TSB150149
-----------

EPA 2010 Aftertreatment Diesel Particulate Filter (DPF) Retention Ring Clarification

Figure 1, Previous Aftertreatment Diesel Particulate Filter Design (DPF) with Retention Ring

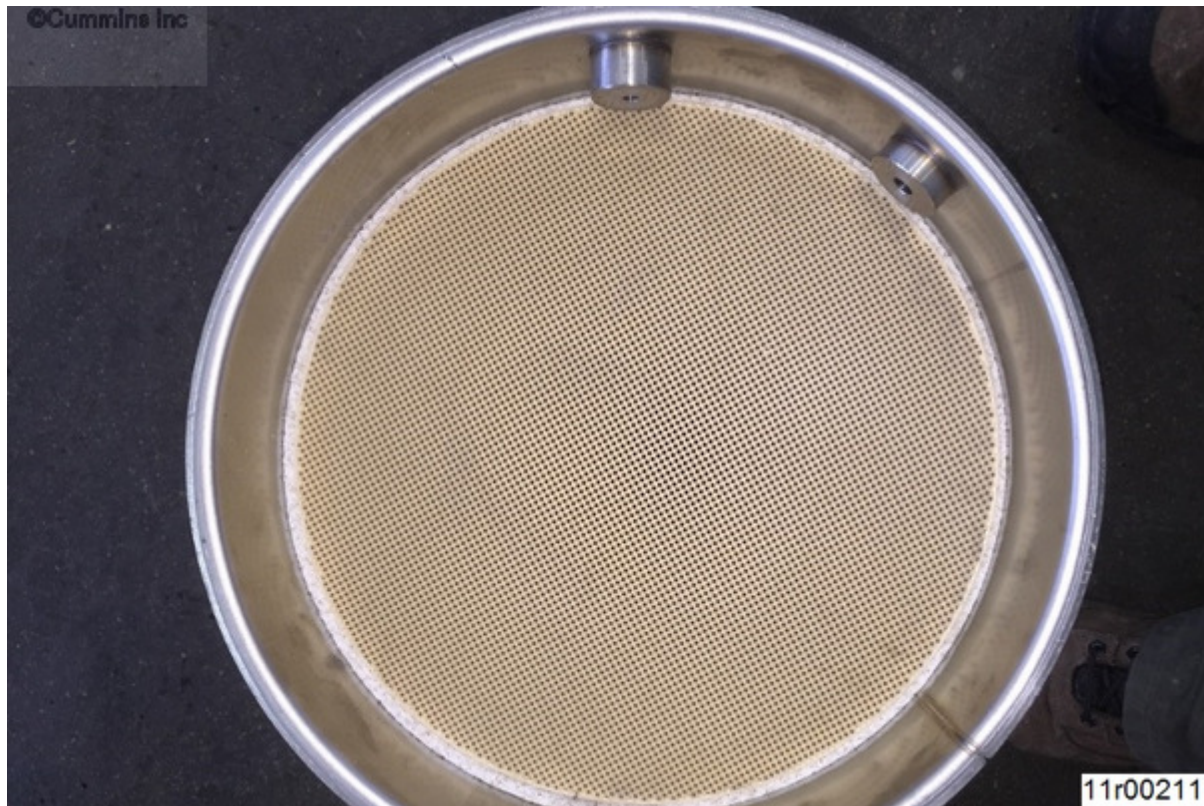
The aftertreatment diesel particulate filter (DPF) design was changed. Because of this physical design change, service locations questioned if the aftertreatment DPF had a manufacturing defect and were unsure if the aftertreatment DPF should be used. This document displays the physical difference between both the new and previous aftertreatment DPF designs.

1. With a retention ring (previous design). See Figure 1 below for example.
2. Without a retention ring (new design). See Figure 2 below for example.

Both aftertreatment DPF designs are acceptable for use.
